Re: Harbor Grove Submittal Review Comments

We have finished reviewing the Harbor Grove submittal package per your request, following are our review comments for your information, review, and distribution to the applicant.

- Civil Plan Set for Harbor Grove, prepared by The Blueline Group, dated 8/9/22.
- Storm Drainage Report for Harbor Grove, prepared by The Blueline Group, Date: May 3rd, 2022 and Revision Date: August 9th, 2022.
- Geotechnical Engineering Study for "Daffron Property", prepared by Earth Solutions NW, LLC, dated July 30, 2021 and Updated July 28, 2022.
- Groundwater Elevation Evaluation for "Proposed Development", prepared by Cobalt Geosciences, dated March 14, 2022.
- Stormwater Pollution Prevention Plan (SWPPP) for Harbor Grove, prepared by The Blueline Group, dated 08/09/2022.
- Revised Critical Area Reconnaissance Report for Sea Pac Homes, prepared by Wetland Resources, dated December 9, 2021.

SHT 10 OF 21

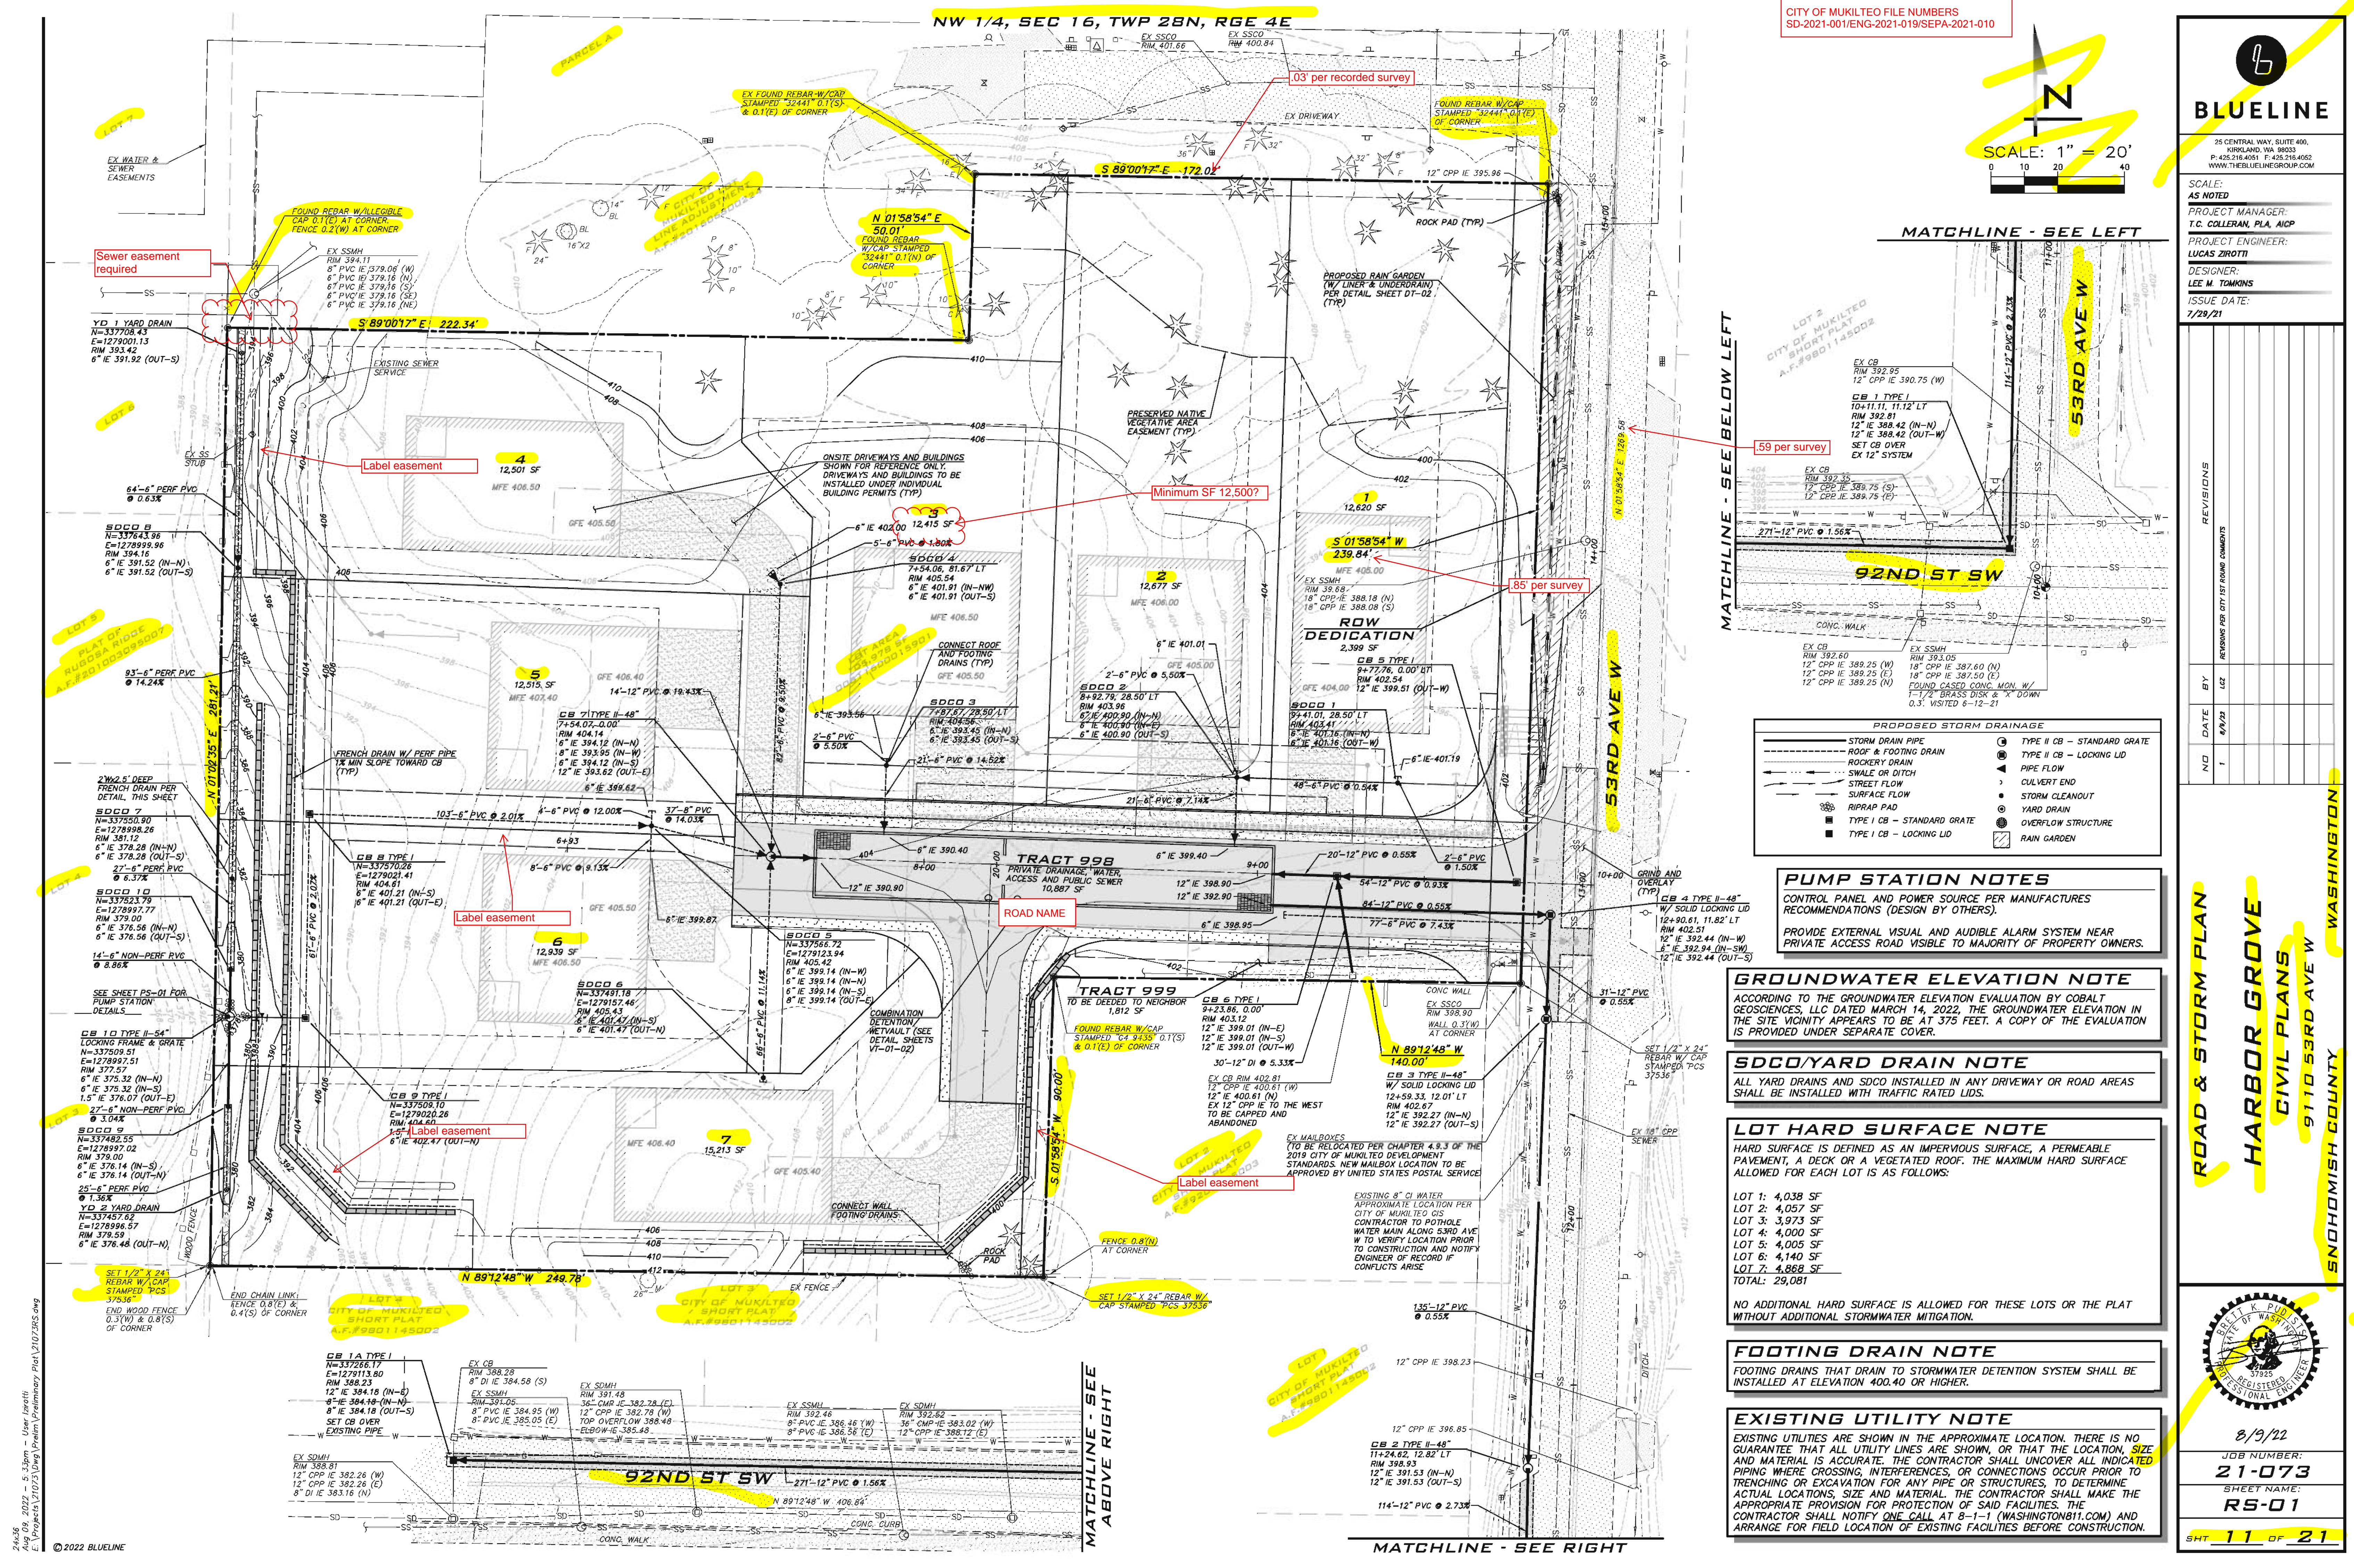
1. The 10' private drainage easement should be called out as a 10' private sanitary sewer easement.
2. Revise the placement of the French Drain with Perf Pipe leader line.
3. EXISTING UTILITIES Note: Change "CONTRACTOR TO VERIFY" to "SHALL VERIFY"

SHEET NAME:
RS-01

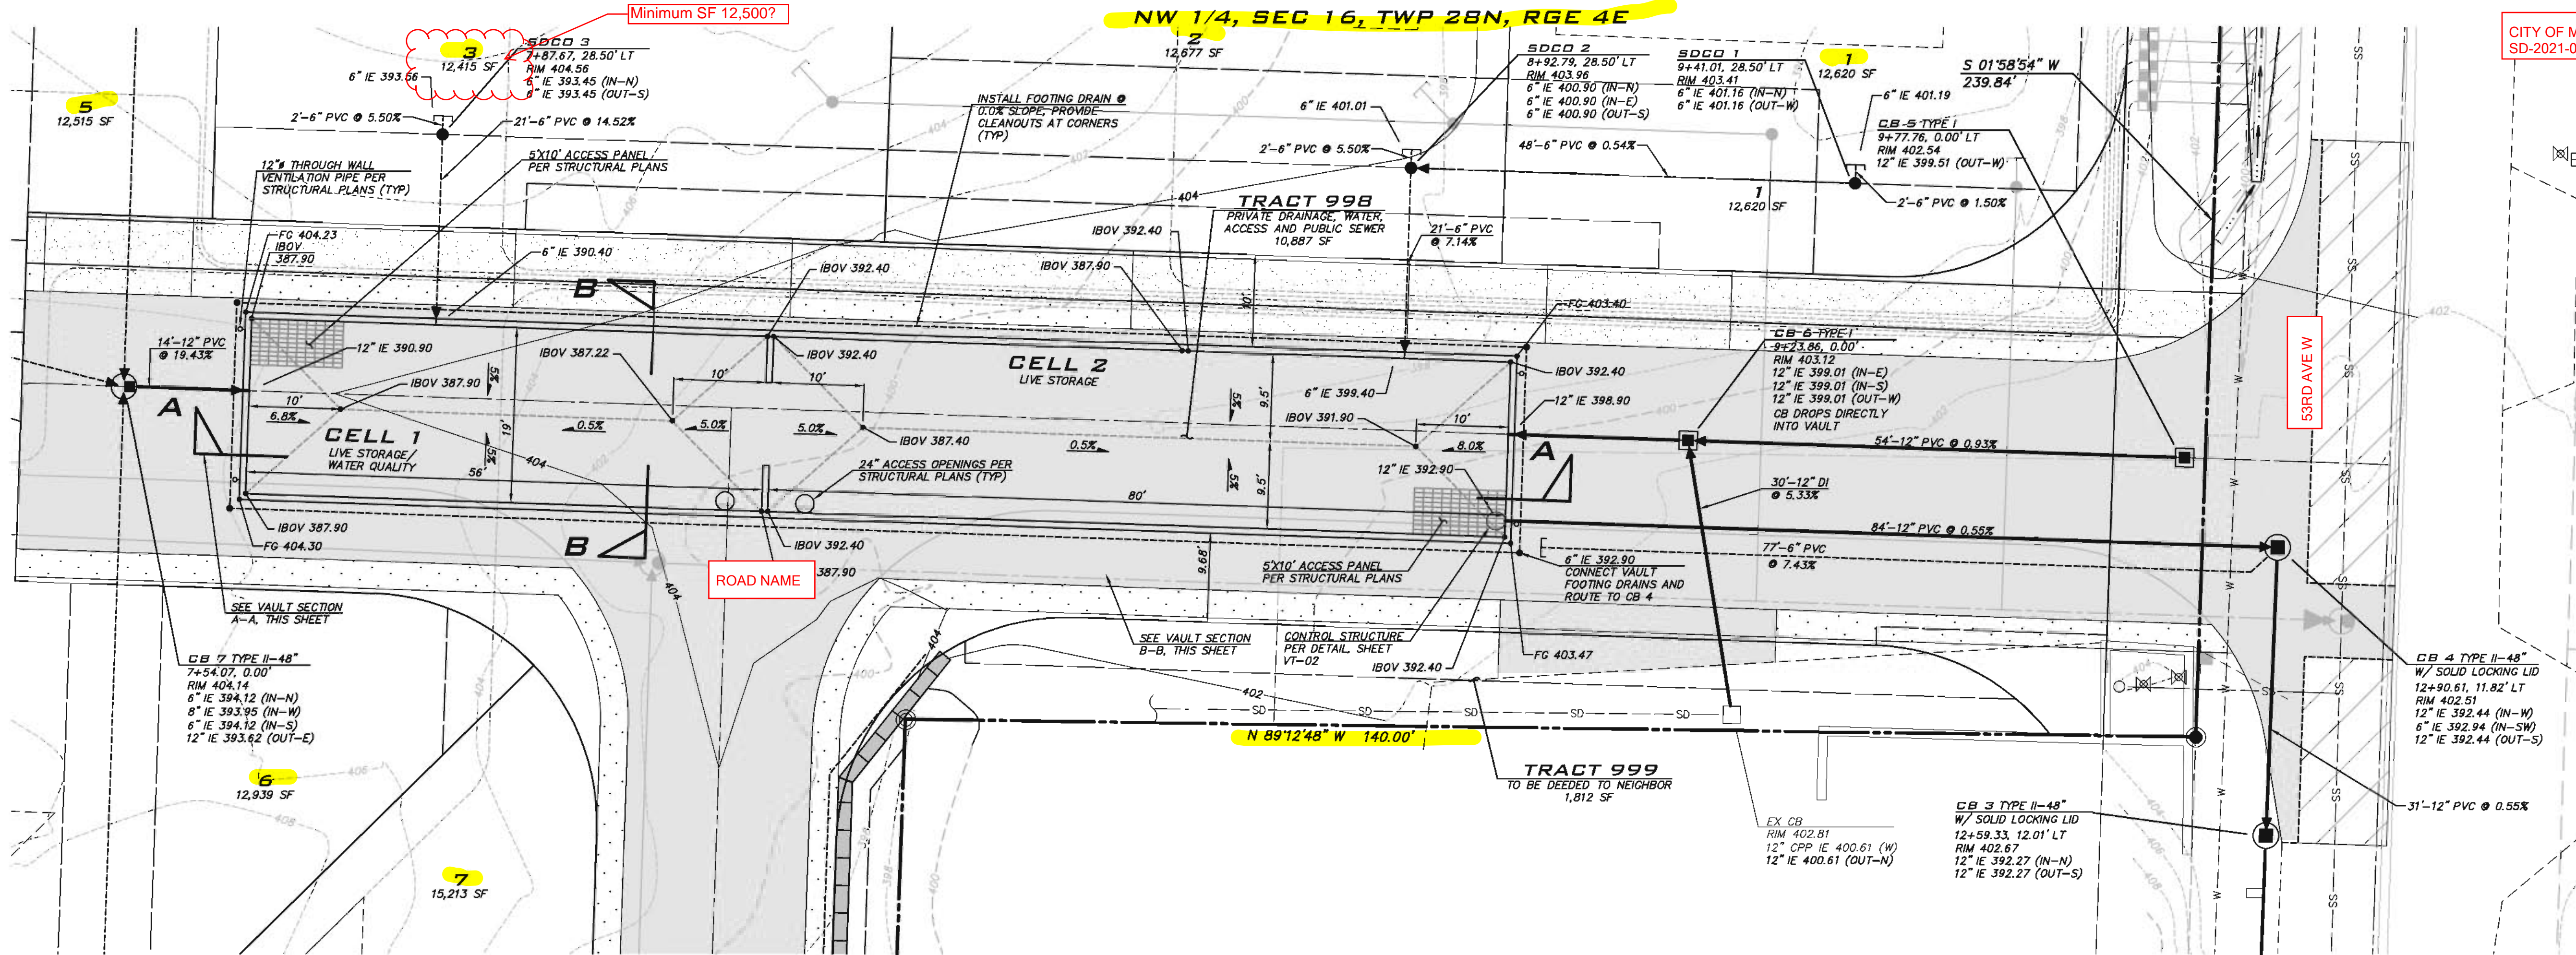
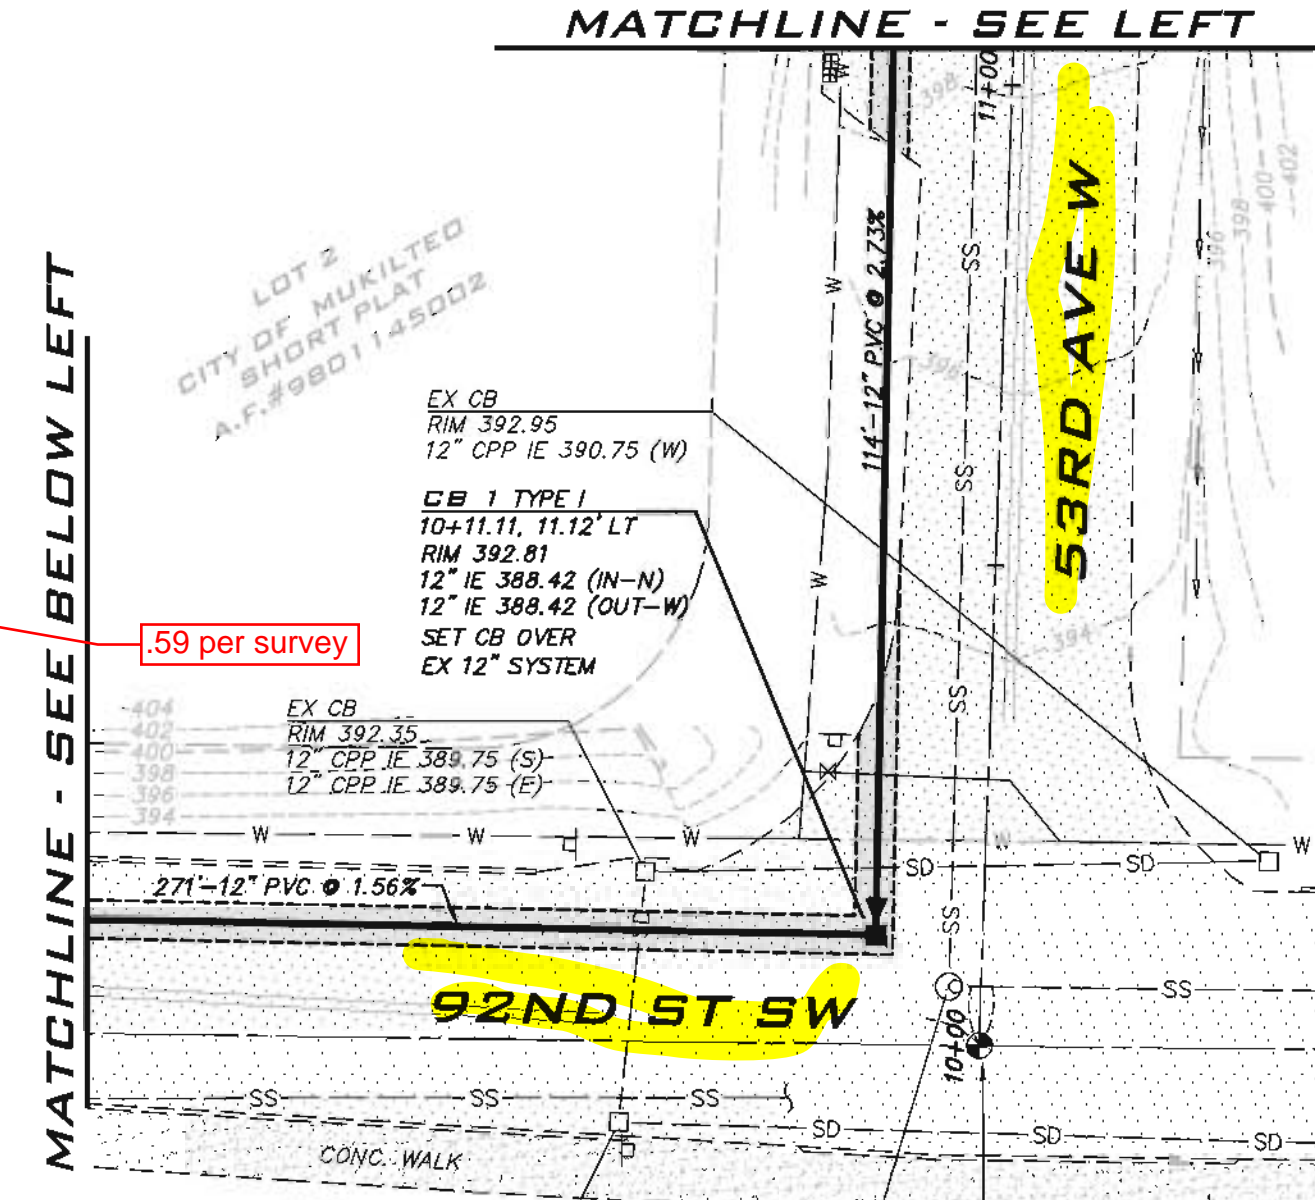
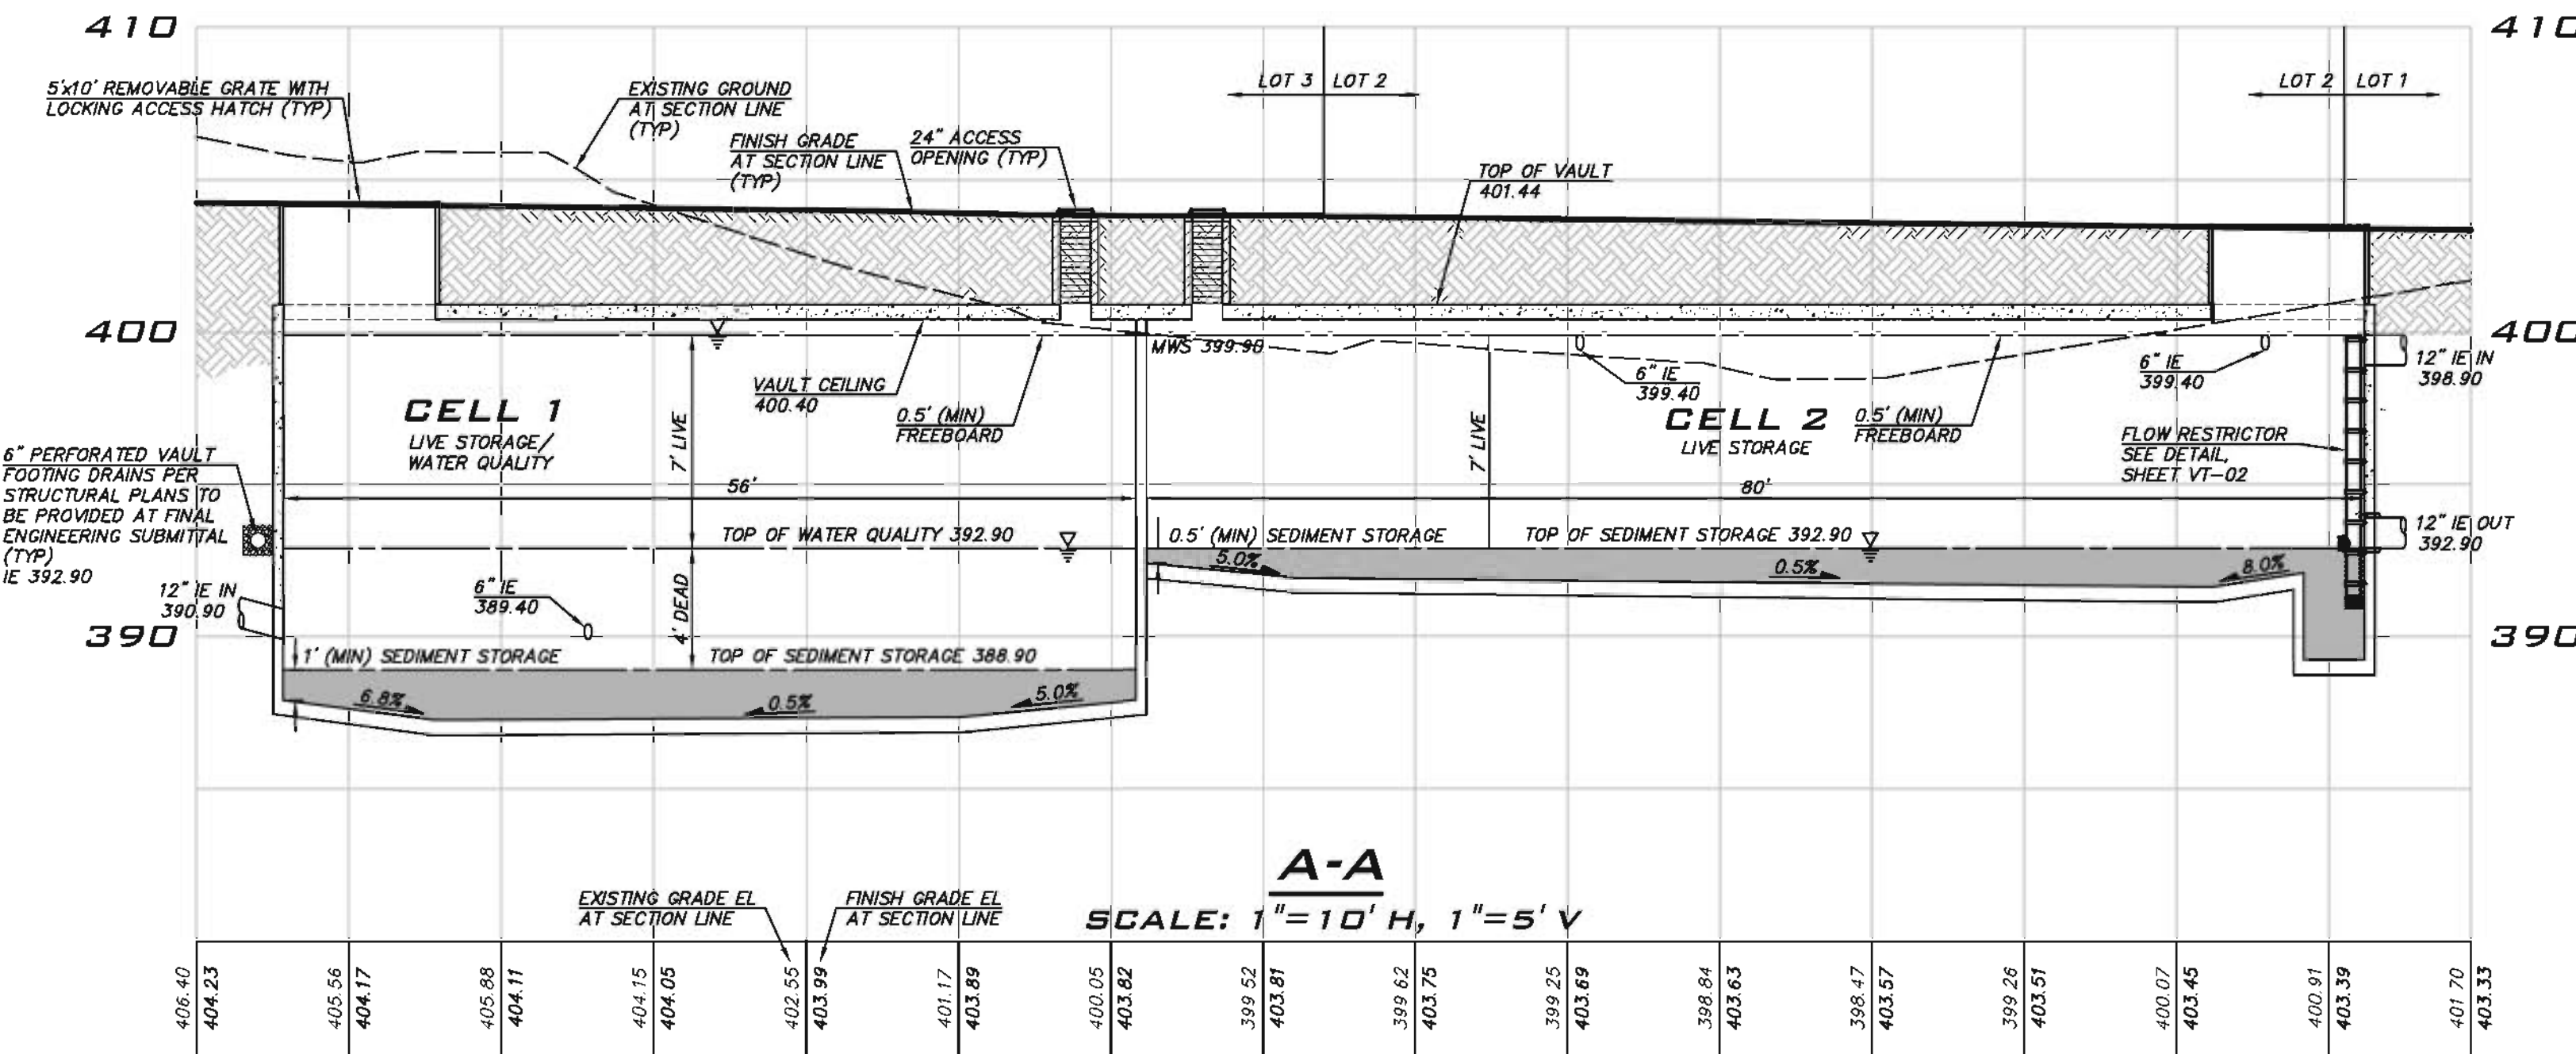
1. It is acknowledged that the applicant has bypassed the existing detention vault on 92nd. However, the existing conveyance system that you are connecting to does not currently see these flows from the project site. Therefore, this system will see an increase in runoff flows and the applicant will need to provide a quantitative analysis of the existing system up to its discharge point on the west side of Hargreaves Pl to make sure the system has capacity to handle the increase in flows.

2. The existing pipe on 92nd St needs to be upsized to at least a 12" pipe. You cannot go from a 12" pipe and then downsize to an 8" pipe.
3. Provide detail. Dimension of the pad, type of rock used, thickness of pad and any geosynthetic material used for separation.

4. Provide details for cleanouts when located in paved areas and when located in landscaped areas.
5. Vault footing drain is set at 392.5. The IE of the drainpipe heading to CB 4 will need to be lowered.

6. Show location of wall footing connections.
7. French Drain detail is not on this sheet, update reference.
8. Raise the IE of these pipes entering the vault as high as you can to limit the amount of backwater in the system. For sure bring the IE up above the top of dead storage elevation so that there will not be permanent standing water in the pipe.

9. This note does not apply to CB 1.
10. Provide a yard drain detail.
11. Where does the underdrain system for this rain garden connect to?
12. How does the existing storm drain intake pipe interact with the rain garden? If it is located at the bottom then it no longer functions as a rain garden, but as a swale. Refine design as needed to accommodate a rain garden design.

13. Per Mukilteo Development Standards 3.6.3.1 catch basins shall be spaced no greater than 150 feet. The civil plans show 271' of pipe between catch basins CB 1 and CB 1A on 92nd St SW. Please add another type 1 catch basin within this segment.

14. EX 8" CI WATER Note: Change "CONTRACTOR TO POTHOLE" to "SHALL POTHOLE".
15. There is a wall at southeast and south of hammerhead and access to Lot 7 up to 10' high, there must be a fence on top of this wall for public safety.
